CITY OF NAPOLEON, OHIO - BUILDING DEPARTMENT

Re. Room addition @ 40 Lafayette.

Footing + Column Detail Days Stults, residence 40 Lafayette Dr. Mapoleon, Ohio Room addition existing piers to be removed and eplaced with (as drawn)
---

Footing + Column Detail
Doug Stults, residence
40 Lafayette Dr.
Mapolcon, Ohio
Room addition existing
piers to be removed and
replaced with (as drawn)
9/29/93

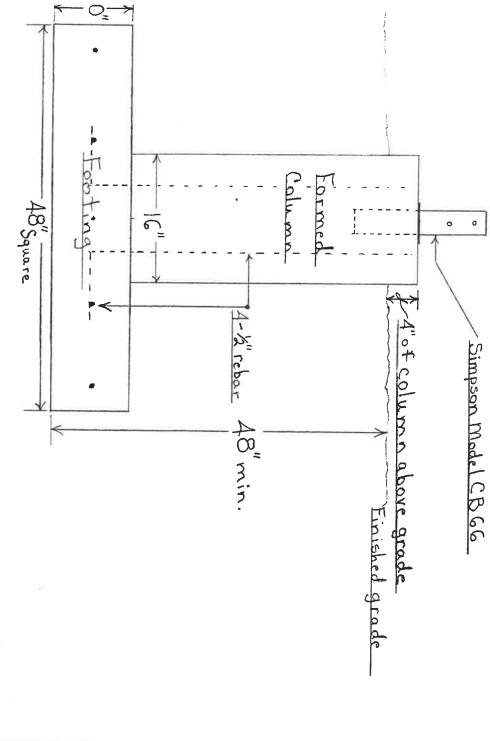
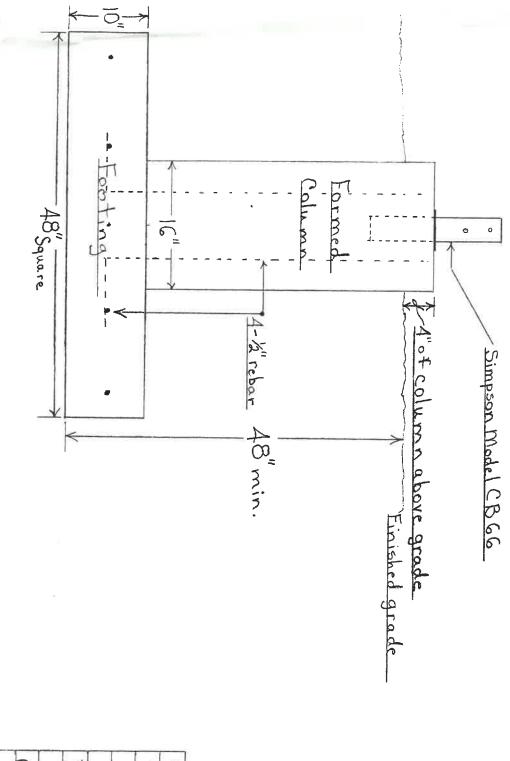
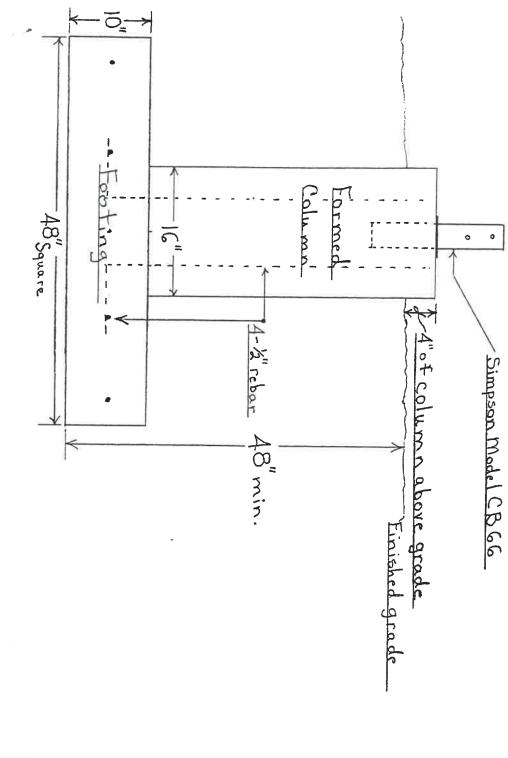
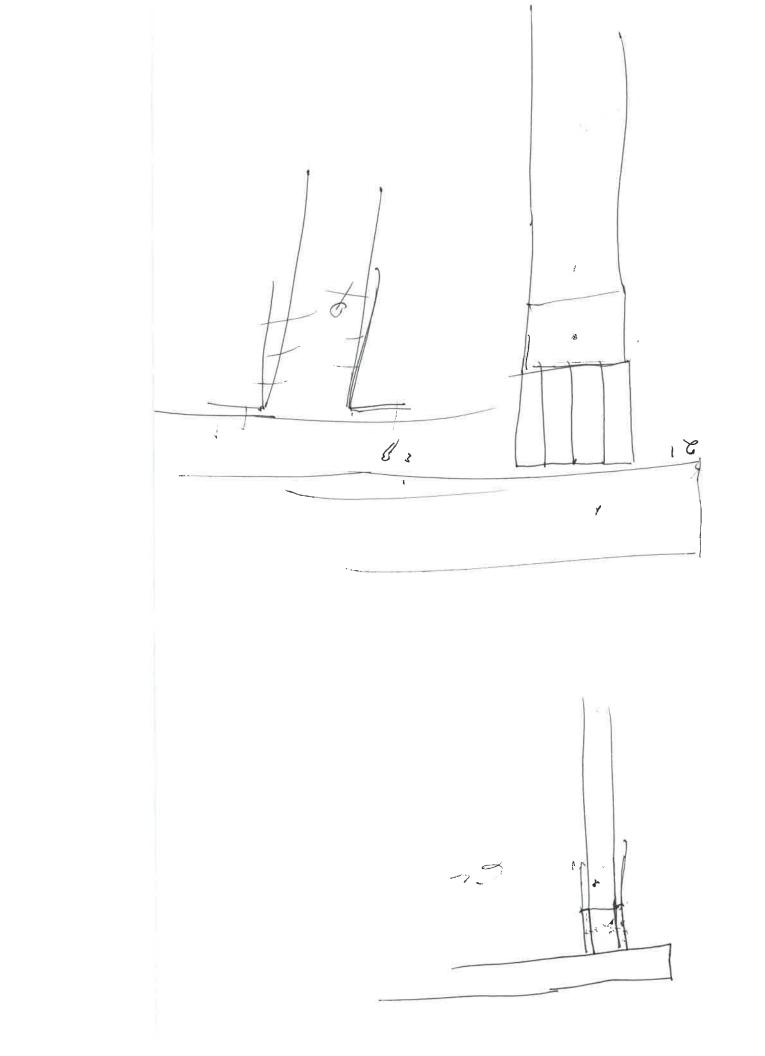
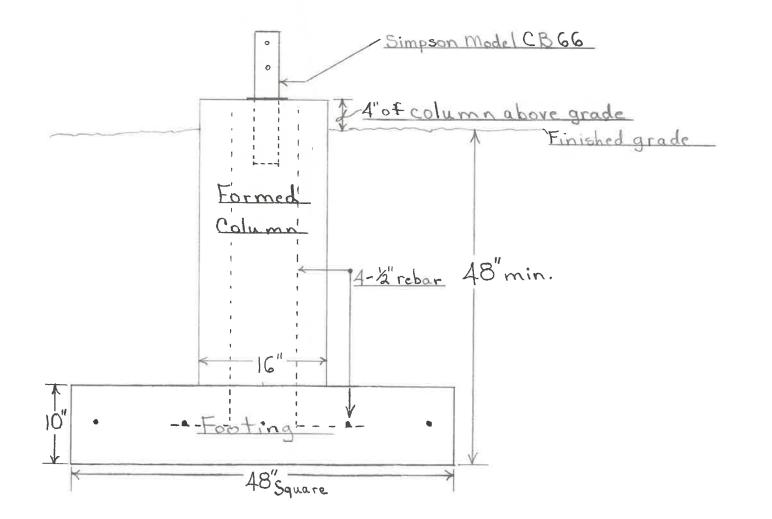
I have review the existing foundation columns which you placed for the above referenced room addition. Unfortunately they do not appear to be providing adequate support for the structure placed above them. The only explanation I can find for this, is that they are not providing the same amount of load bearing capacity as the original house structure footings, and because the two structures are attached explains the movement which is occurring.

I am suggesting that the existing columns be removed and replaced with the type and size shown on the enclosed sketch, as this would more equal the existing house structure footings load bearing capacities.

6 X6 P.T. Pillar 60 Retention Must be centered on 10" Pad FEET 8' coment 5/8 × 16" Be Rods ot 4-Ventical 5/8 x 21"-Re Rods 0 0 Form 24
